Change in socket from Without V-Lock to with V-Lock.

Product Change Notification						4793-Consolidate to V-Lock as standard		
owner	creation date	release date	released by	change order	rev	page	D40 074 474	
mansurva	09.06.2023	08.08.2023	muehlema	2026121	Α	1 of 2	D10-074-471

1 Products affected.

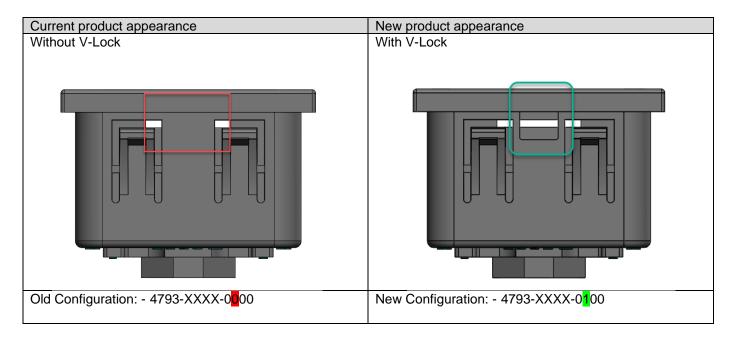
\boxtimes	Form	Socket includes V-Lock Notch
	Fit	
\boxtimes	Function	Introduce locking functionality V-Lock as a standard
	Manufacturing	
\boxtimes	Label	Check new Configuration Code
	Packaging
